Updating the Sweeper Headers

Models Affected

Engine	Serial Number Range
HP525 EFI	0M956572 and below
HP600 SCI, HP662 SCI, HP700 SCI	0M962885 and below

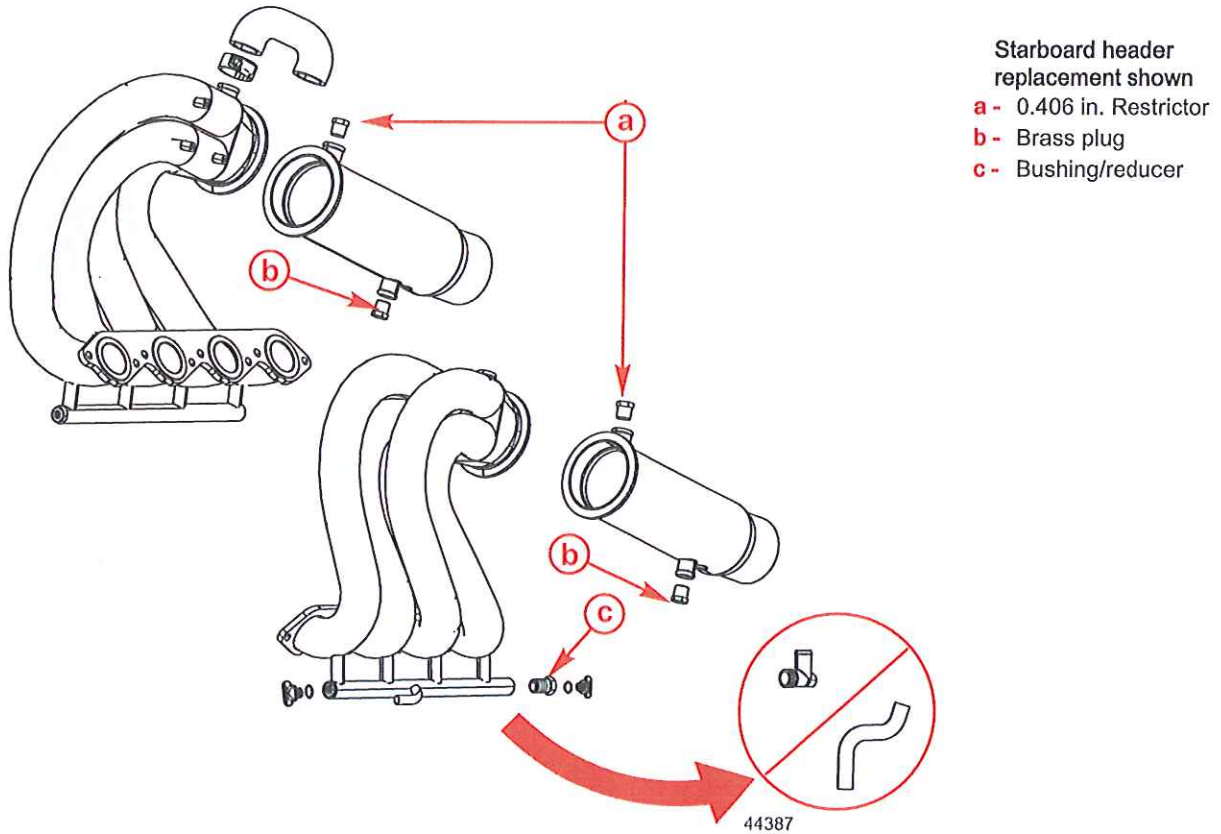
1. Remove the hose adaptor (elbow) fitting and the by-pass hose from the header that is not being replaced.
2. Install the bushing/reducer.
3. Remove the plug from the hose adaptor and screw it into the bushing reducer.

IMPORTANT: Both tailpipes must have a 0.406 in. (13/32 in.) restrictor installed in the top fitting.

4. Install a 0.406 in. restrictor in the top fitting of the starboard tailpipe.
5. Install a brass plug in each of the lower tailpipe fittings
